Office Action Summary

10/524,575

BACULY, ERIC J.

DETAILED ACTION

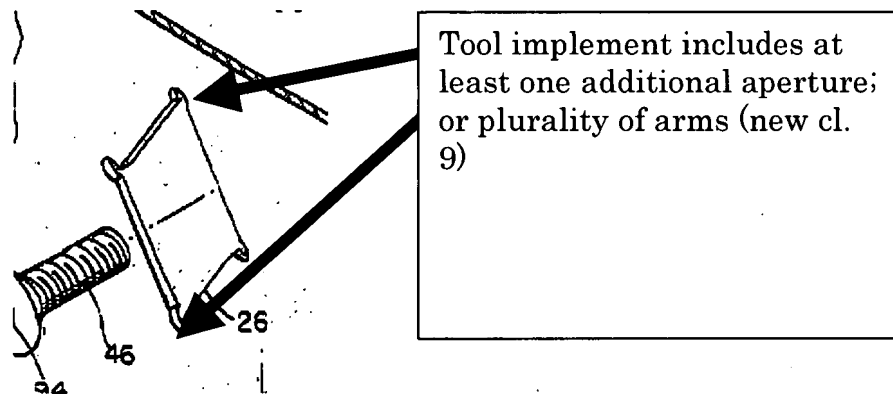
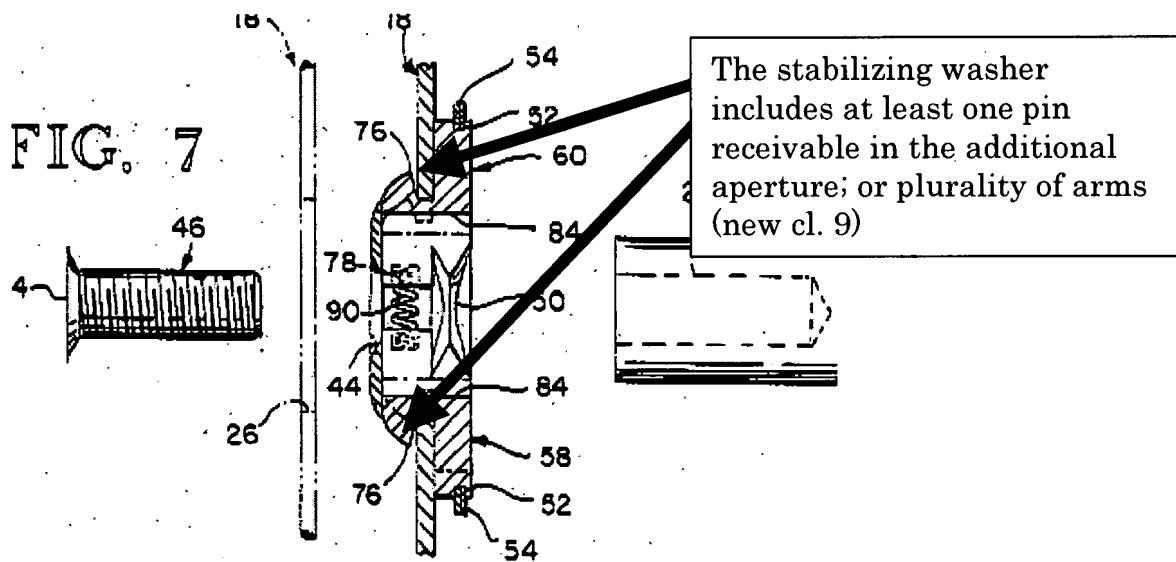
cl. 1, 9: quick change mechanism (10) comprising: a shaft (22), tool implement (blade 18), stabilizing washer (44), threaded fastener (46), capable of passing through the hole of the blade as shown in fig 7;

cl. 2: the washer has a non-circular profile & the blade includes an aperture;

cl. 3: the washer has a central hub & arms (fig 6);

cl. 5: the shaft is internally threaded bore (fig 7-8);

cl. 6-7: implement being saw blade / lawnmower blade (note: no additional elements recited to prevent the blade 18 to be used as lawnmower blade);

cl. 8: at least 2 apertures shown & at least one pin:

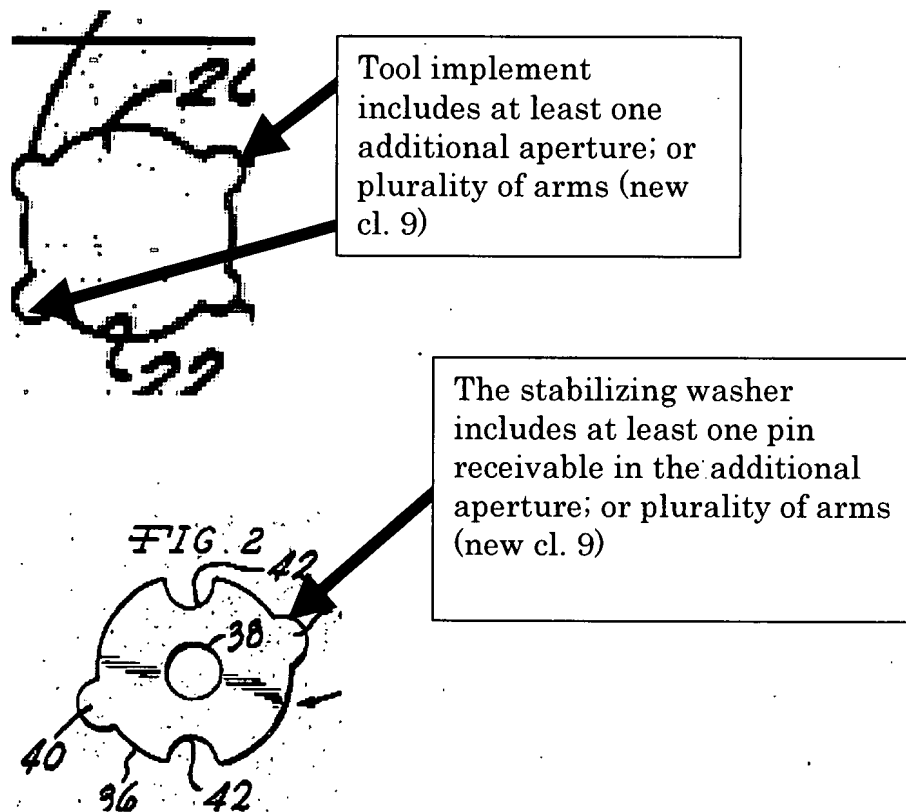
cl. 1, 9: quick change mechanism (fig 2-5) comprising: a shaft (50), tool implement (blade 10), stabilizing washer (adapter 34), threaded fastener (62), capable of passing through the hole of the blade as shown in fig 5, i.e. when ref 40 & 28 are lined up;

cl. 2: the washer has a non-circular profile & the blade includes an aperture (fig 1, 2);

cl. 3: the washer has a central hub & arms (fig 2);

cl. 4: the shaft is externally threaded bore (fig 4);

cl. 6-7: implement being saw blade / lawnmower blade (note: no additional elements recited to prevent the blade 18 to be used as a saw blade);

cl. 8: at least 2 apertures shown & at least one pin:

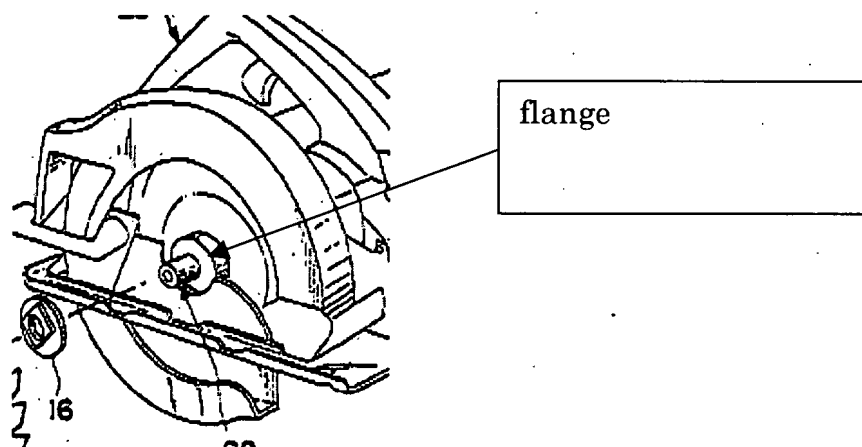
Applicant argued that Wiley does not show a flange. It is not correct. Wiley improves upon the quick connector, therefore the prior art shaft is relevant and not shown with the improved invention detailed esp. in fig. 7 & 8. Therefore the flange considered in the rejection is as shown below:

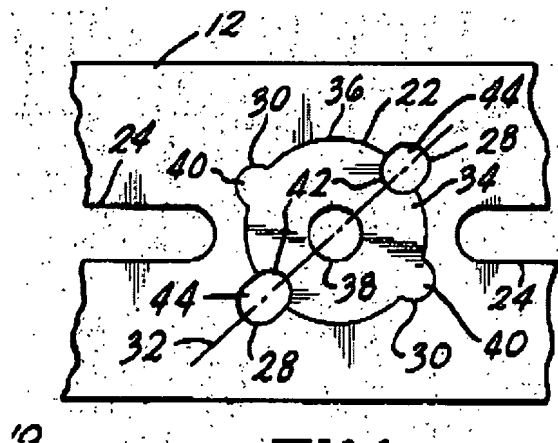
In response to applicant's argument that the washer of Tygh is a pressure washer, the fact that applicant has recognized another advantage which would flow naturally from following the suggestion and/or teaching of the prior art cannot be the basis for patentability. As Thygh shows below, the washer 34 when turned would not pass through aperture 28, and vice versa, when the arms 40 aligned with ref 28 it would pass through, therefore loosening fastener 62 on the shaft 58 would allow the washer 34 to pass through the tool implement without removing from the shaft the washer & fastener. The claim does not exclude other elements that may be shown by Thygh. It has been held that a recitation with respect to the manner in which a claimed apparatus is intended to be employed does not differentiate the claimed apparatus from a prior art apparatus satisfying the claimed structural limitations. *Ex parte Masham*, 2 USPQ2d 1647 (1987).
